Community Association Responses

2025 October 1

Calgary **West Segment - Long-Term Concept Option 2** Provides six lanes on 16 Avenue N.W.

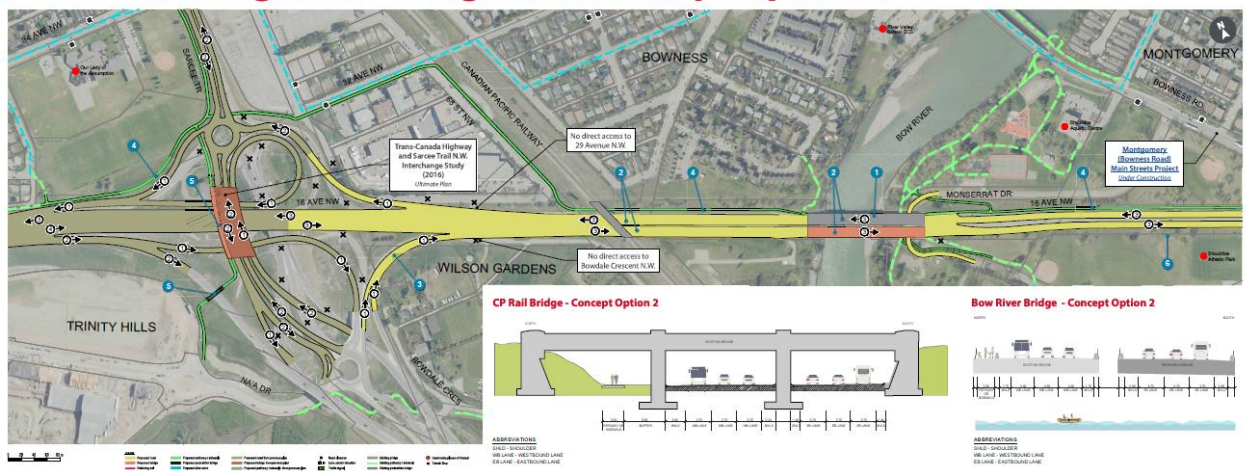
We have attached the West Segment Mobility plan where a pedestrian bridge to Trinity Hills was proposed from Bowness. We see the green spaces on the north and west side of the development as potential tie in locations for a pedestrian bridge or other types of walking infrastructure for Bowness and Trinity Hills.
